**CLARIFICATION MEETING ON THE SUPPLY AND INSTALLATION OF VIDEO
CONFERENCING FACILITY HELD AT MOFEP CONFERENCE ROOM ON 26TH
AUGUST 2010**

The meeting was opened at 10:00 by Mrs. Agatha Nketsiah, Director (ICT) who indicated that the purpose of the meeting was for tenderers to seek clarification on the tender launched for the supply and installation of a video conferencing facility (VCF).

Proposed room design

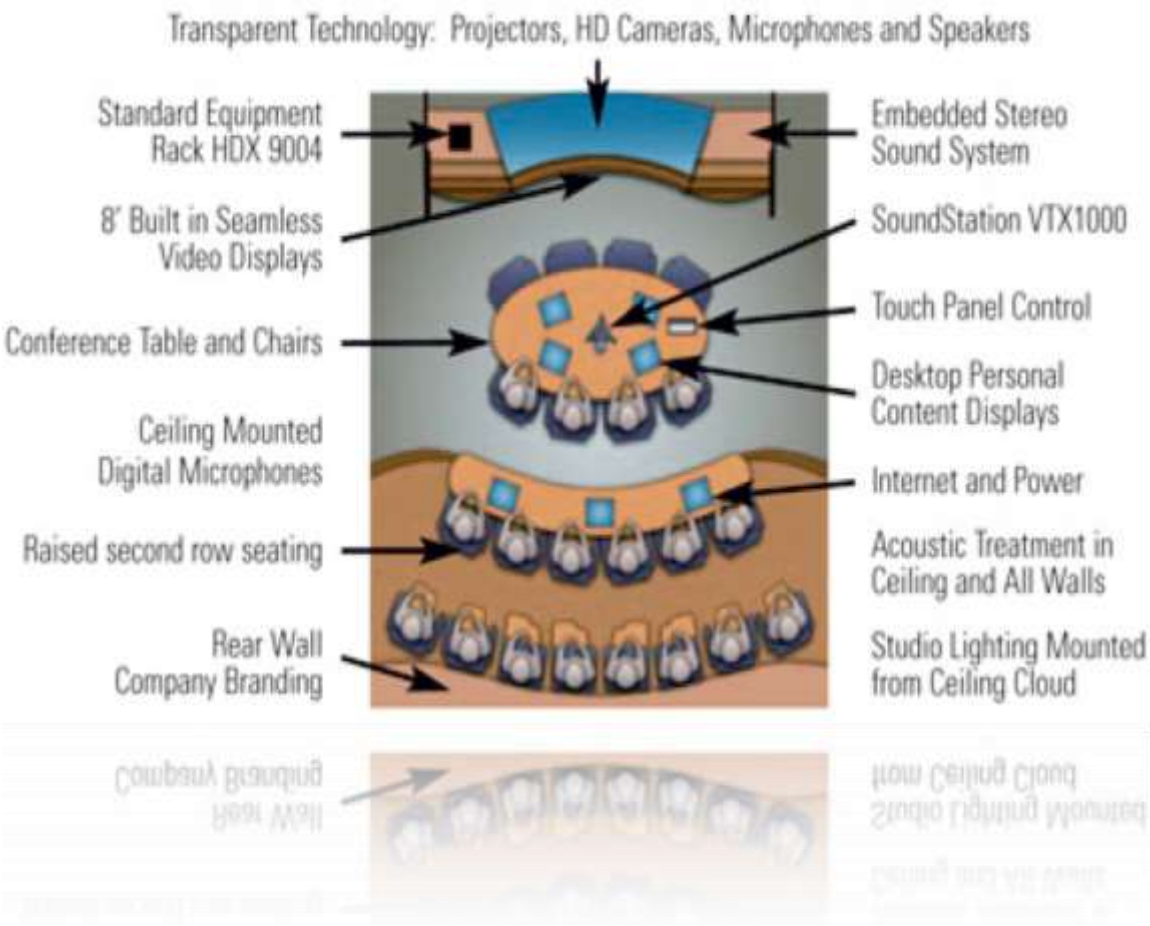
The picture below gives an idea how the room will be design. There will not be raised floor
